UNITED STATES PATENT AND TRADEMARK OFFICE

APPLICATION NO.	FILING DATE	FIRST NAMED INVENTOR	ATTORNEY DOCKET NO.	CONFIRMATION NO.
10/055,083	01/25/2002	Terry Chou	12675 B	8107

Office Action Summary

DETAILED ACTION

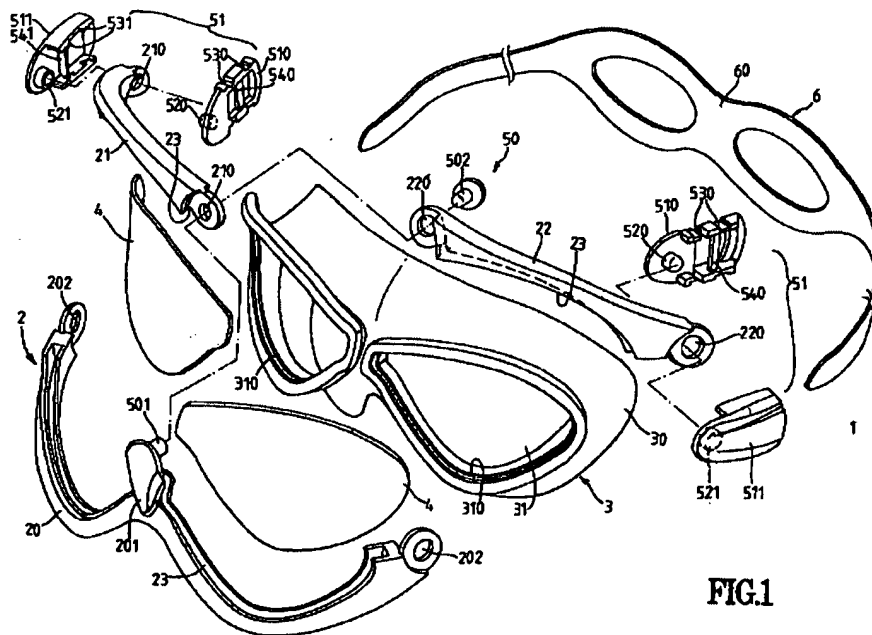
Chiang discloses a lens/frame assembly for swimming goggles having a frame 2 made of a rigid material with slight flexibility and a lens holding compartment 23 having a bridge portion (see figure below) in the middle thereof. The bridge portion has an upper wall and a lower wall. Two lenses 4 are tightly received in the lens-holding compartment 23 of the frame 2. A connecting block 201 is securely received in the bridge portion of the lens-holding compartment 23 and securely mounted to the frame 2 to thereby securely retain the lenses 4 in place. The connecting block 201 connects the upper wall and the lower wall of the bridge portion.

With regard to claims 8 and 17, the bridge portion of the frame 2 comprises two engaging pieces 502 respectively formed on an upper wall and a lower wall of the bridge portion. Each engaging piece 502 includes a peg, the connecting

block comprises two engaging holes (see figure above) and each peg 502 extends through an associated one of the engaging holes of the connecting plate 201.
